To: Joe Turner, Hearings Officer
From: Eric Rutledge, Associate Planner
RE: Revised Staff Report for LU 2020-023 VAR / MM
Date: March 3, 2021

The purpose of this memo is to outline changes made to the original staff report for LU 2020-023 VAR / MM dated February 17, 2021. The changes are in response to the public hearing held on the application on February 24, 2021.

PROPOSAL: The applicant is proposing a Class B Variance and Major Modification to an Approved Site Plan (SP 06-12 / VAR 06-12) at 21003 SW Pacific Hwy. The subject site is 0.16 acres and is improved with a 417 SF drive-thru coffee stand (former Coffee Cottage) and associated site improvements. The development proposal will reconfigure the on-site vehicle circulation, parking, and landscaping in order to accommodate a second 10 ft. wide one-way drive-thru lane. The on-site stormwater detention pond will be removed and replaced with a cartridge system. Vehicle access will continue to be provided from two existing driveways along SW Borchers Drive. Two parking stalls will be re-located on-site and two will be located on an adjacent property across SW Borchers Drive. No building expansion is proposed at this time. A Class

Figure 1: Snip of Site Plan showing location of proposed variances. The proposed exceptions to the underlying standards are intended to overcome development challenges related to the narrow configuration of the site.

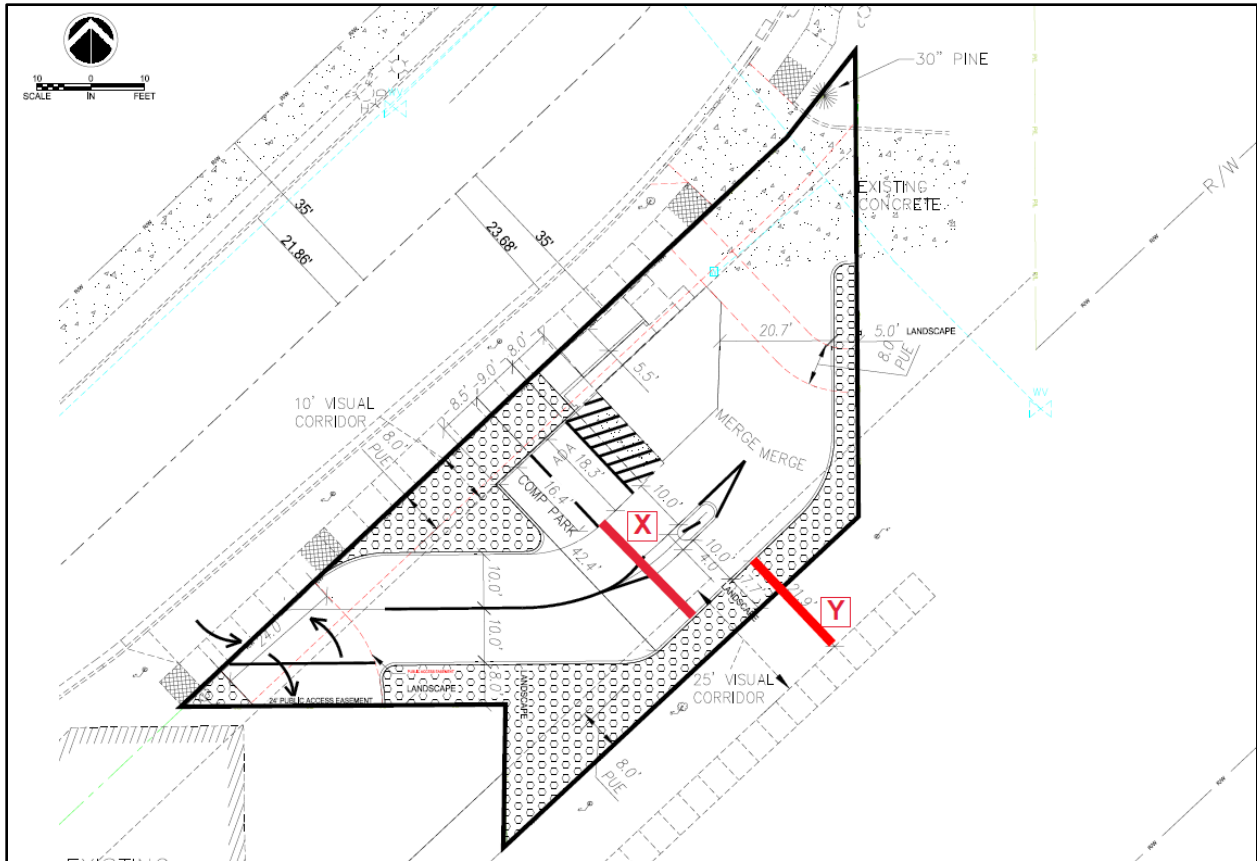
Code Section	Minimum Standard	Request with Variance	Percent Change	Figure 1 Label
SZCDC § 16.94.020(B) Table 2 - Width of one way-drive aisle for off-street parking area; compact stalls at 90°	26 ft.	24 ft.	7.7%	X

SZCDC § 16.142.040(A) – Width of visual corridor along an arterial; Hwy 99W	25 ft.	21.9 ft.	12.4%	Y
---	--------	----------	-------	---

ANALYSIS: As shown on the revised site plan (Exhibit D1 – Sheet R1), the applicant is proposing two 90° stalls. One of the 90° stalls will be a compact stall with a depth of 18 ft. and therefore requires a 26 ft. wide aisle behind the stall. The applicant has requested a 7.7% reduction to this standard for final width of 24 ft. The request meets the variance approval criteria as discussed in the findings for SZCDC § 16.84.

The applicant has requested a Class B Variance to reduce the visual corridor width from 24.5 ft. to 21.9 ft in order to add a second one-way drive-thru lane. The reduction represents a 12.4% change from the underlying visual corridor standard of 25 ft. The request meets the variance approval criteria as discussed in the findings for SZCDC § 16.84.

Figure 2: The subject lot size, shape, and dimensions. (Washington County Tax Map 9/18/2019)

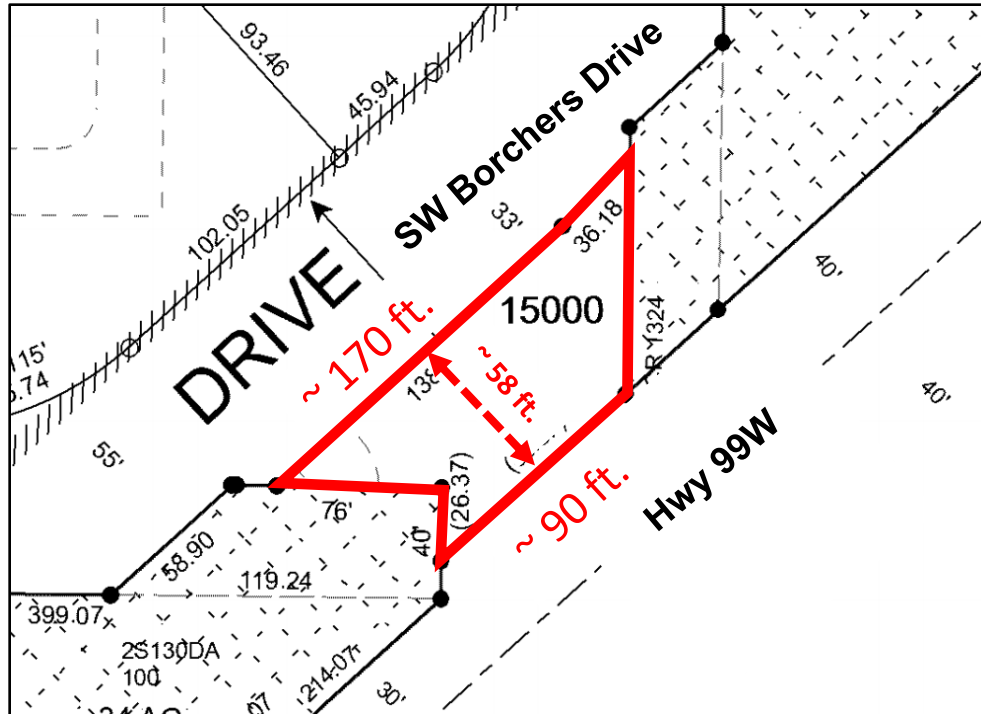
The lot was created as a long narrow double frontage lot, located between SW Borchers Drive to the northwest and Hwy 99W to the southeast (Exhibit C2). Development of the site in 2007 (SP 06 / 12 VAR 06 / 04) required a 10 ft. right-of-way dedication along SW Borchers Drive. The width of the subject lot was therefore reduced to approximately 58 ft., creating additional challenges for future redevelopment of the site. The existing lot size, shape and dimension is shown in Figure 2 below.

The purpose of the Retail Commercial zone is to provide general retail and service uses that neither require larger parcels of land, nor produce excessive environmental impacts. The proposed variances will allow a reduction to underlying standards while allowing redevelopment of the site consistent with the purpose of the RC zone. The variance will allow the site to add a second drive-thru lane without being detrimental to the surrounding properties. The existing lot size and shape are a result of the site history and past development requirements (right-of-way dedication) and were not self-imposed by the applicant.
